22 SUB2009-00035

SHARON ACRES SUBDIVISION

SHARON ACRES SUBDIVISION

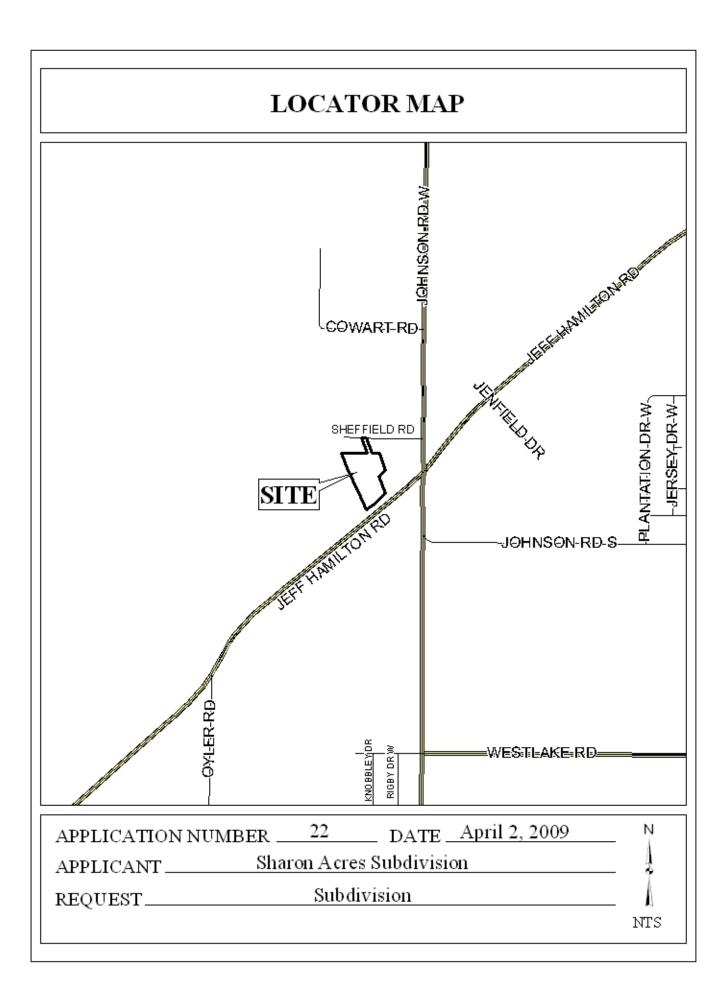
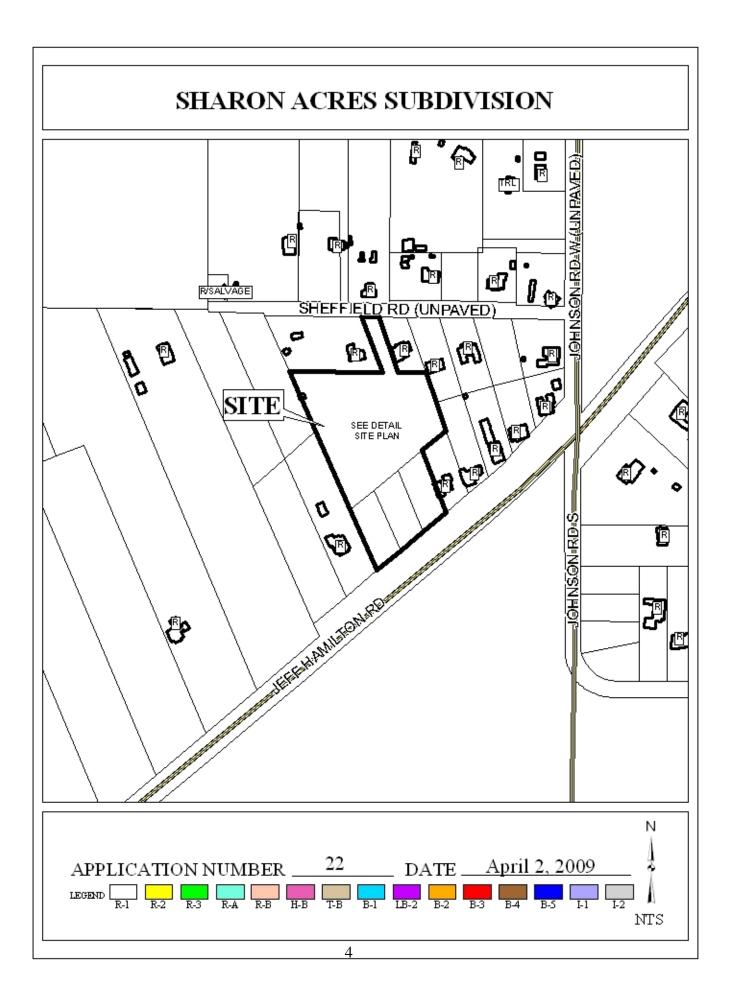
To the North, the site fronts Sheffield Road, an unpaved minor street with 40' of right-of-way. Section V.B.14 of the Subdivision Regulations requires minor streets without curb and gutter to have a minimum 60' right-of-way. If approved, the applicant should revise the plat to dedicate sufficient right-of-way to provide a minimum 30' from the centerline of Sheffield Road. Furthermore, Section V.D.4 of the Subdivision Regulations states that, except for lots on private streets, every lot shall abut a dedicated and maintained public street. However, since the applicant is not increasing the number of lots, a waiver here would be appropriate. To the South, the site fronts Jeff Hamilton Road, a major street with varying right-of-way. As the Major Street Plan requires a 100' of right-of-way, the applicant should revise the plat, if approved, to dedicate sufficient right-of-way (if needed) to provide a minimum 50' from the centerline of Jeff Hamilton Road.

As proposed, Lots 3 and 4 are flag lots with 25' of frontage each on Jeff Hamilton Road. Lot 3 also has approximately 64' of frontage on Sheffield Road. Lots 1 and 2 have approximately 185' and 88' of frontage along Jeff Hamilton Road. If approved and as a means of access management, a note should be placed on the final plat stating that Lot 3 is denied access to Jeff Hamilton Road; Lots 1, 2, and 4 are limited to one curb cut to Jeff Hamilton Road; and Lot 3 is limited one curb cut to Sheffield Road, with the size, location, and design to be approved by County Engineering and in conformance to AASHTO standards.

None of above mentioned conditions has been addressed. Furthermore, the applicant is not increasing the number of lots, but simply rearranging four legal lots. It is staff's opinion that an approval here would set an unwanted precedent for flag lots to be created in the area. If approved, however, the setback line should be revised on the Lots 4 and 5 to provide 25' from the where the "poles" meet the "flag" portions of the lots; and a note should be placed on the final plat stating that no future subdivision of Lots 4 and 5 will be allowed until additional adequate frontage on public street is provided.

The plat meets the minimum size requirement for developments with access to public water and individual septic tanks. However if approved, it is requested that the applicant revise the preliminary plat to label the lots with their sizes in square feet (in addition to acreage), or provide a table on the plat with the same information.
